MEMORANDUM

To: Lisa Vandiver (NOAA)
From: Geoffrey Glover and Brian Daley (HW)
Date: December 13, 2018
Re: Assessment of green cay headcut stabilization project and recommended repairs
cc: May Cornwall Adams, Rudy O'Reilly (NRCS), Julie Wright (NRCS), JP Oriol (CZM), Marlon Hibberts (NOAA), Rob Ferguson (NOAA)

Figure 6. Locations of erosion and boulder movement (in red circles) over preliminary as-built survey

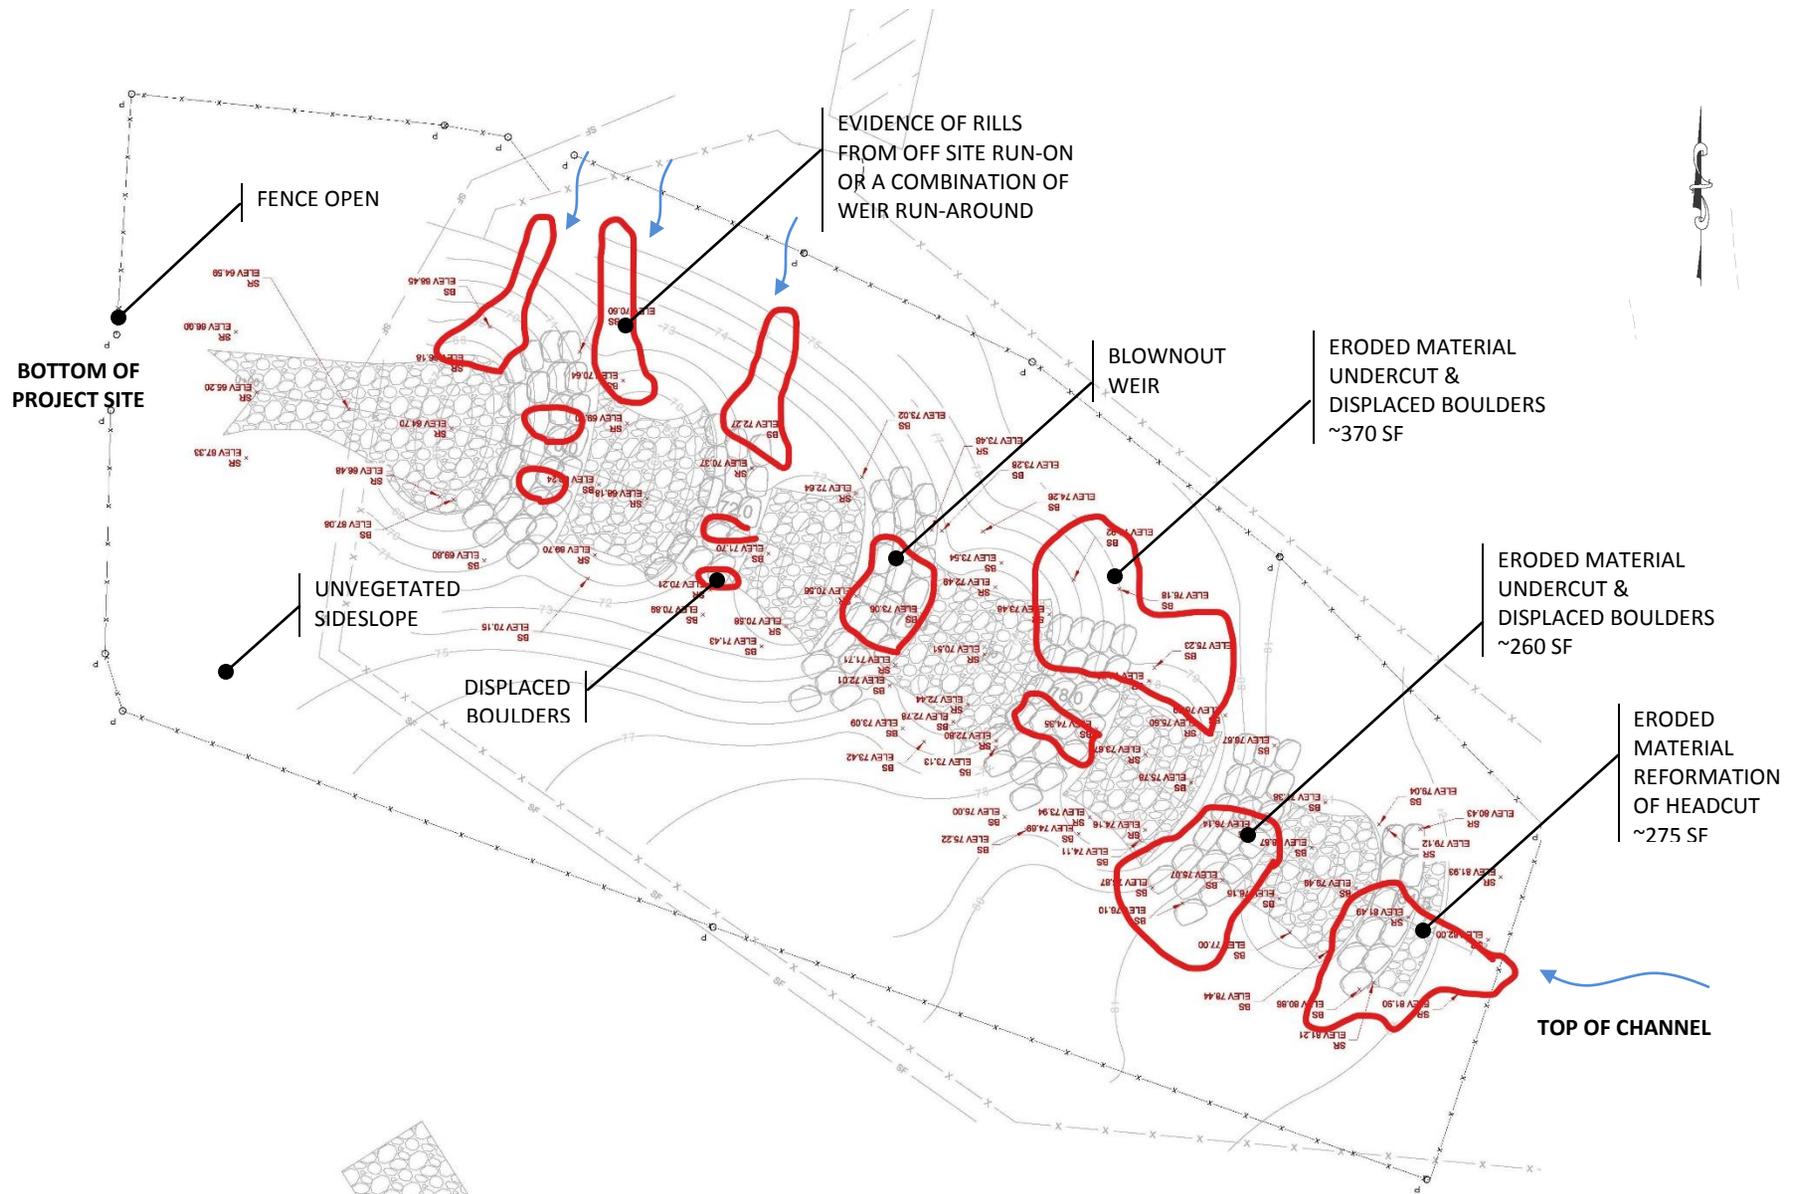
1. The headcut advanced to the east (uphill) post-hurricane. The new erosion has extended beyond the fence line by approximately 3-4 ft and is approximately 2 feet deep. This erosion has compromised the integrity of fence posts, and created a nick point where continued erosion may occur (Figure 1). The small stone apron that had been installed at the top of the channel washed out completely, due in part to installation issues as well as a minimalist design and use of non-specified materials.

5. The uppermost stone weirs appear to have washed out due to large flows in the channel (enough to move boulders). There were six weirs in the original design that were constructed of 2 – 6 rows of individual boulders with a minimum boulder diameter of 3 feet. The designed weir length was to be 8 feet, with the weirs extending 2 – 7 feet further up the side slopes. Boulder sizing was designed based on modeling of flows for the 100-yr storm, which may have been exceeded during and after the hurricane. In addition, there were issues during construction (e.g. smaller average boulder size and inaccurate placement) that may have also contributed to weir instability and flow “run around.”

6. Bank erosion resulting from flow “run around” the weirs was observed at a number of locations (Figure 4). This may have been exacerbated by abnormally high rain fall and flow

Figure 6 is a site map mark up showing the locations of erosion and boulder displacement these features.

Figure 7. Site sketch and detail showing immediate and short-term repair recommendations.

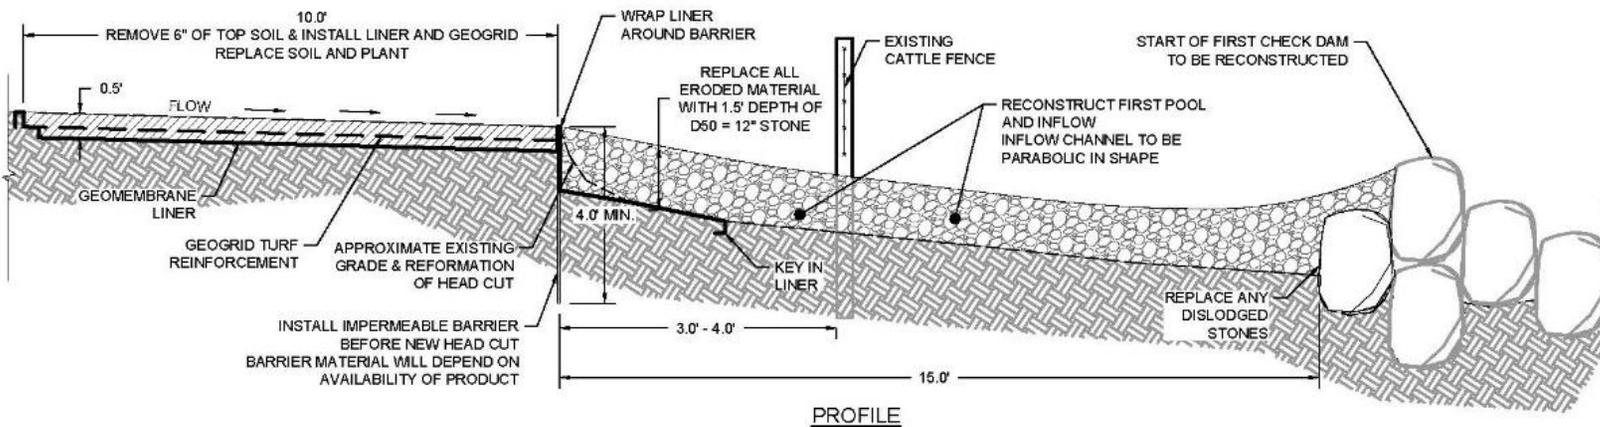
Figure 7 provides a sketch showing the location of immediate and short term measures, and includes a detail illustrating the proposed measures at the top of the headcut.

- NOTES:
1. KEY BOULDERS INTO THE STEP POOL BANKS AND EXTEND INTO THE ABUTMENTS A MINIMUM OF 48" TO PREVENT FLOW FROM OUT FLANKING THE WEIRS.
 2. CUT BACK ANY VEGETATION WITHIN THE WORK AREA TO PROVIDE PROPER CONDITIONS FOR INSTALLING EROSION CONTROL DEVICES PROPERLY.

INFLOW AT HEADCUT
NOT TO SCALE

3. **Repair the two uppermost stone step-pools and extend weirs.** We recommend reconstructing and enhancing the first two steps pools. The weir wings should be extended an additional 3-7 feet up the side slopes. Proper construction is critical to prevent shortcutting or run-around at high flows and to maintain proper elevation differences between weir crest and pool inverts. While laborers and equipment are on site, consider reshaping any downstream weirs where boulders were dislodged.
4. **Fill and revegetat eroded or bare slopes.** Add suitable soil and reseed southern corner of project site where vegetation never established. Where slopes were distrurbed for step-pool repairs, this area will need to be revegetated as well. Use alternative soil stabilization techinque such as wood chips rather than erosion control blanket, if needed.
